FINAL INITIAL STUDY/ MITIGATED NEGATIVE DECLARATION

STUDENT SERVICES REPLACEMENT, BOOKSTORE MODERNIZATION AND PICO PROMENADE IMPROVEMENTS PROJECT

**SANTA MONICA COMMUNITY COLLEGE DISTRICT
OFFICE OF FACILITIES PLANNING
1900 PICO BOULEVARD
SANTA MONICA, CALIFORNIA 90405**

FEBRUARY 2008

Figure IV-2
Winter & Summer Project Shadows

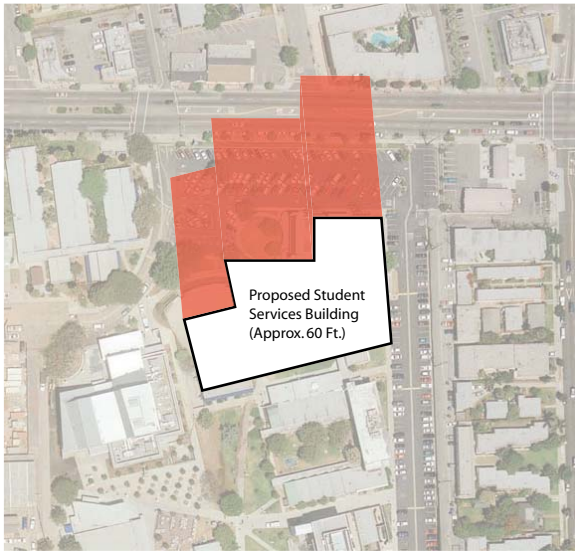
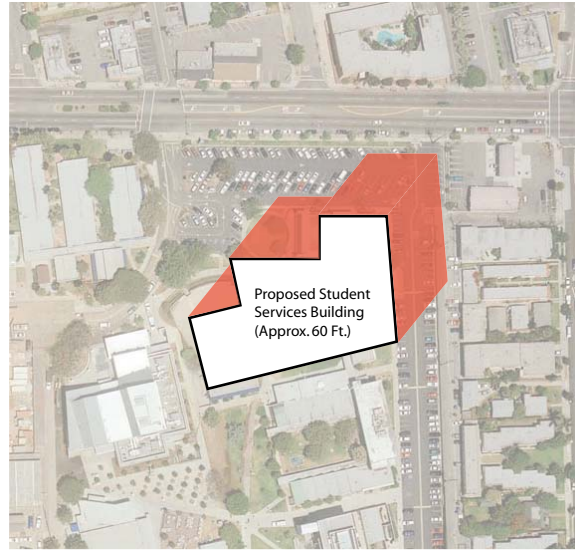
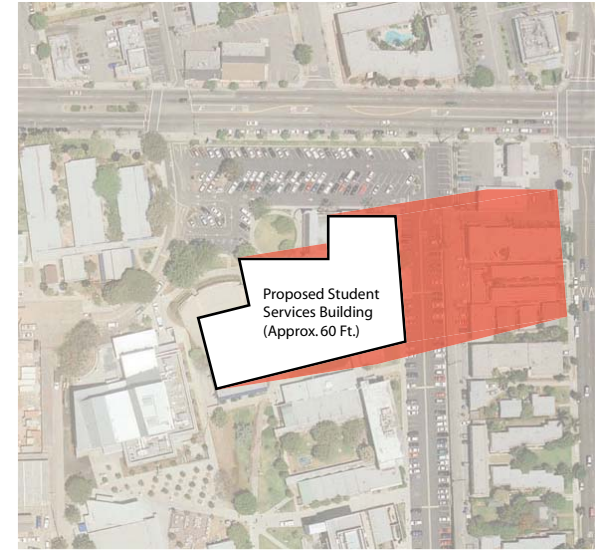
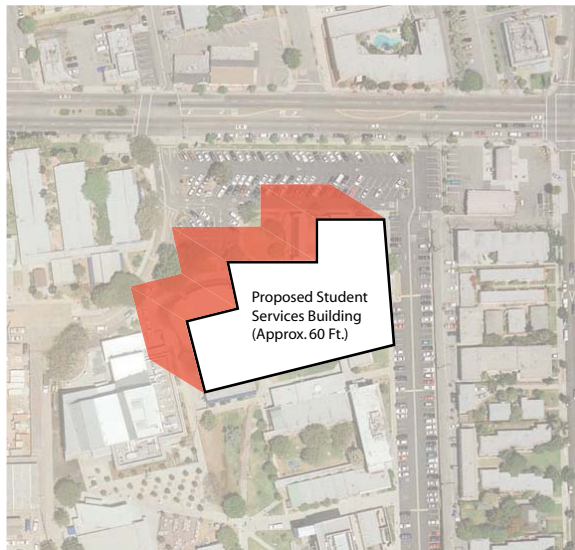
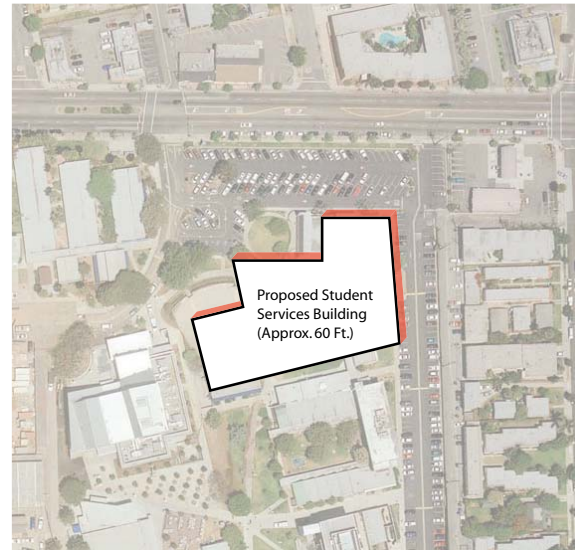
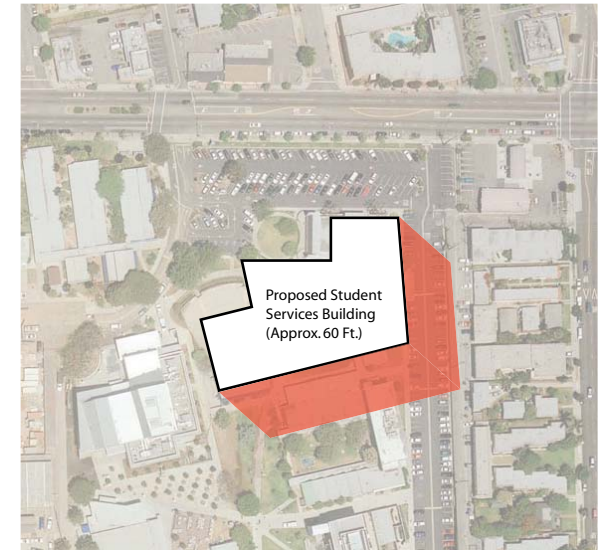
- c. Shadows – The “Winter and Summer Project Shadows” Figure IV-2 on Page IV- 15 of the document show that in winter, the proposed 60-foot tall 3-story Student Services Replacement Building will start casting shadows over the city alley east of the campus by 12 noon and, by 3 PM, four residential parcels on the west side of 20th St. (south of the gas station) will be completely covered by shadow. We can’t tell from the document when, between noon and 3 PM, the shadows will begin to completely cover the residences.

For purposes of this analysis, a shade and shadow impact would be significant if the proposed Project creates substantial shade/shadows that affect shadow sensitive uses (e.g., residential uses or outdoor spaces associated with residential or recreational uses or existing solar panels) for more than 3 hours between 9:00 a.m. and 3:00 p.m. from late October to early April or for more than 4 hours between 9:00 a.m. and 5:00 p.m. from early April to late October. As shown in Figure IV-2, the project’s winter project
